# COMMUNITY DEVELOPMENT DEPARTMENT REPORT

SUBJECT: Centerville Subdivision No. 4 - FP  
FP-2026-0021

LOCATION: 5200 S. Hilldale Avenue at the southeast corner of Hillsdale and E. Amity Road in the NW ¼ of the NE ¼ of Section 33, Township 3N, Range 1E, Parcel No. S1133120708

## D. Final Plat

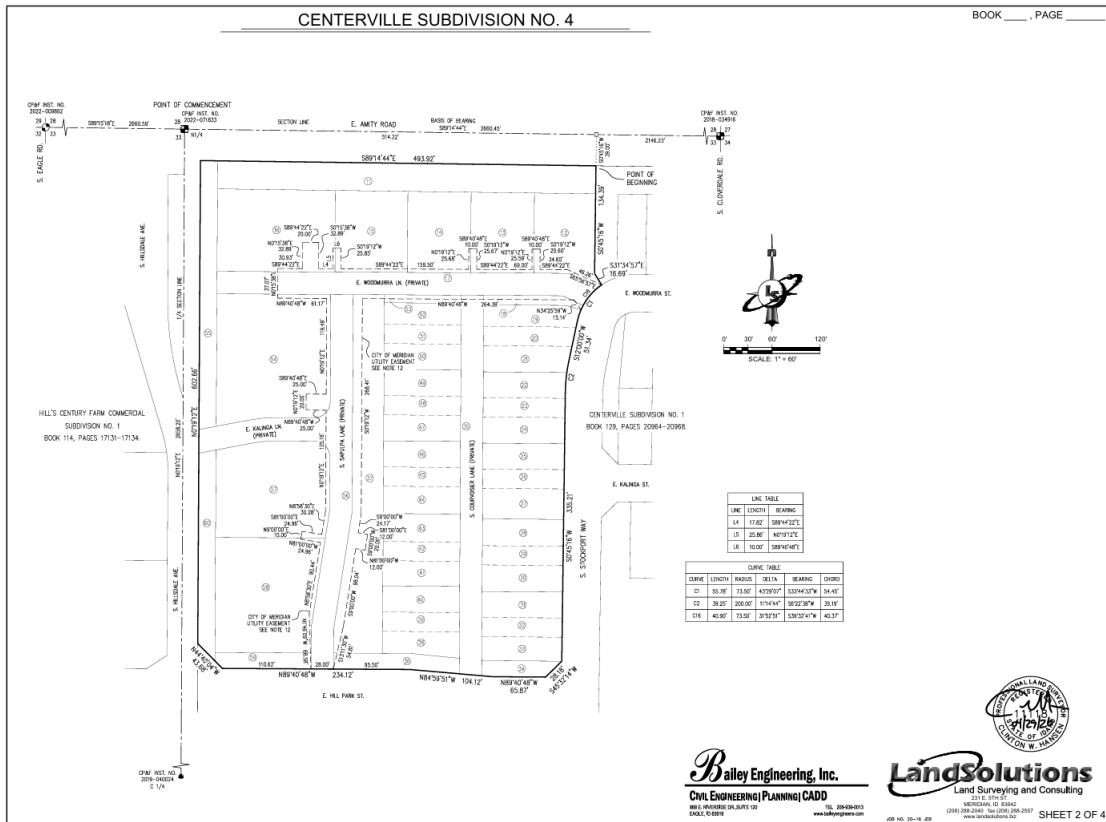
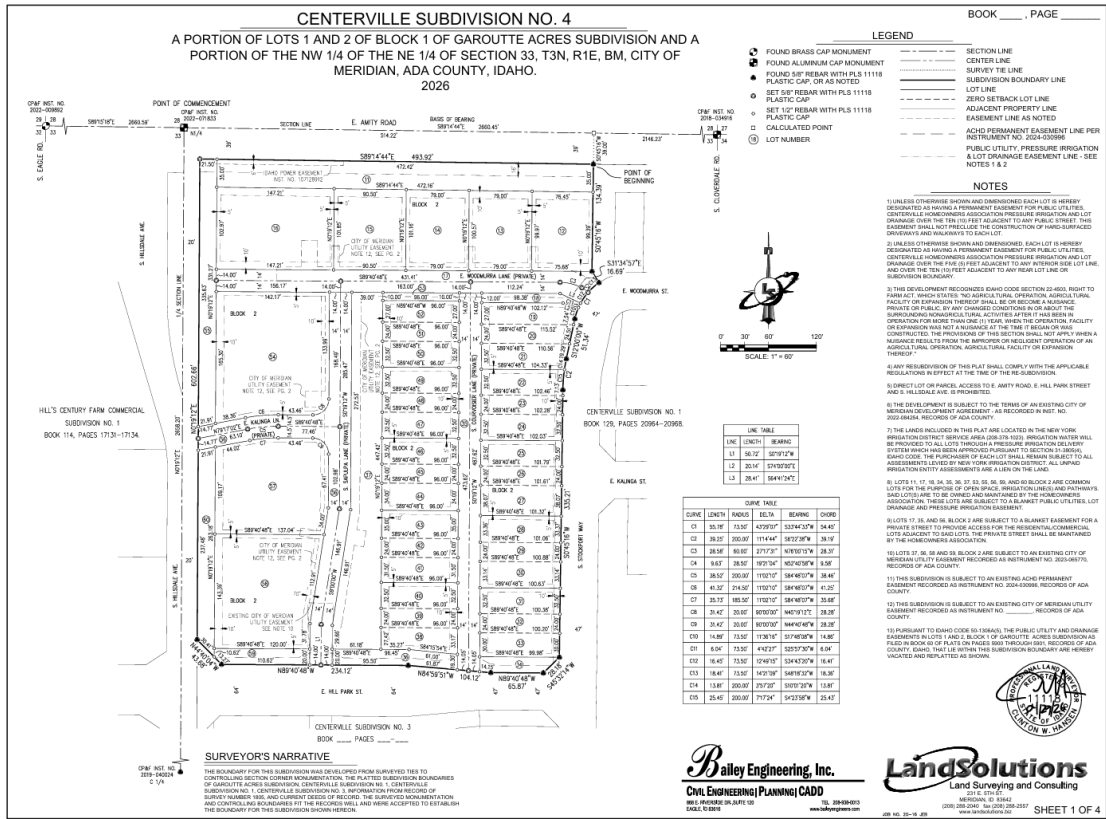
- a. Note #2: This note calls out a 5-foot-wide interior lot setback instead of the 3 feet allowed per UDC. Change to meet the current UDC setback of 3 feet unless you are providing 5 feet.

- b. Note # 12: Include the instrument number for the Meridian utility easement.
  - c. Graphically depict a 15-foot pedestrian easement between lots 43, 44 and 27, 28, Block 2.

- d. Lot 35 was approved as an alley not a private road. Remove the street name from the alley as they are not named.
4. The landscape plan prepared by Jensenbelts Associates, dated April 28, 2026, will be approved with the CZC for the multi-family and commercial lots.
